Simplifying Equation 33-15.

In July meeting we have updated Figure 33-26 and Equation 33-15 for D1.8.

Figure 33-26 – I_rush-2P and I_rush current and timing limits, per pairset in POWER_UP state

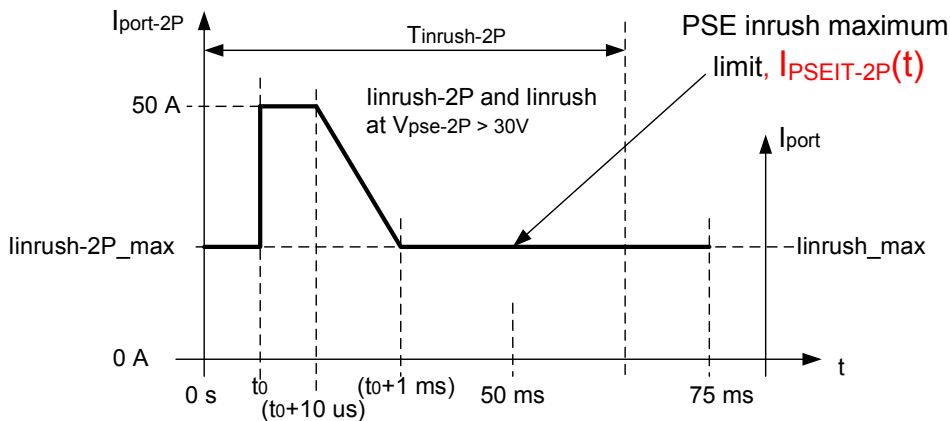
1. In Figure 33-26 there is text missing marked in **RED**.
2. Equation 33-15 can be simplified per the work done in:
http://www.ieee802.org/3/bt/public/may16/darshan_18_0516.pdf (See Annex A for reference in this document.

1. Update Figure 33-26 with the additions marked RED:

Figure 33-26 – linrush-2P and linrush current and timing limits, per pairset in POWER_UP state

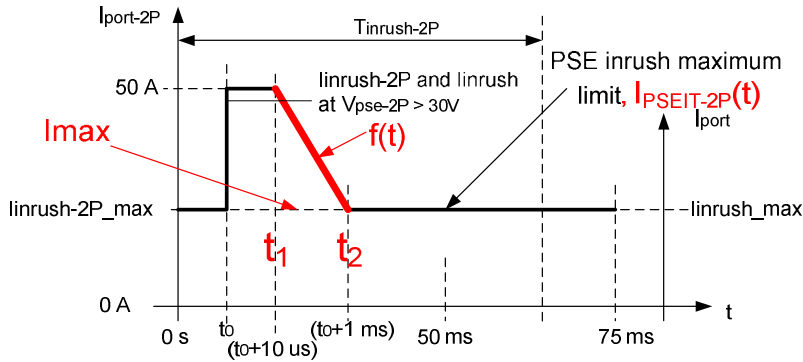
The following derivation will address $f(t)$ part which is marked in red:

From observation, the value of equation 33-15 in the range 10usec to 1msec in D1.7 should be the same as in D1.8 in the range $(t_0 + 10 \times 10^{-6}) < t < (t_0 + 0.001)$ without being dependent in t_0 since its slope described by $f(t)$, the maximum value (50A) and the minimum value (Inrush-2P_max or linrush which is described by I_{max}) will remain the same.

t_0 is limited to 49msec (50msec maximum PD inrush time duration minus 1msec PD max transient time during PD inrush period).
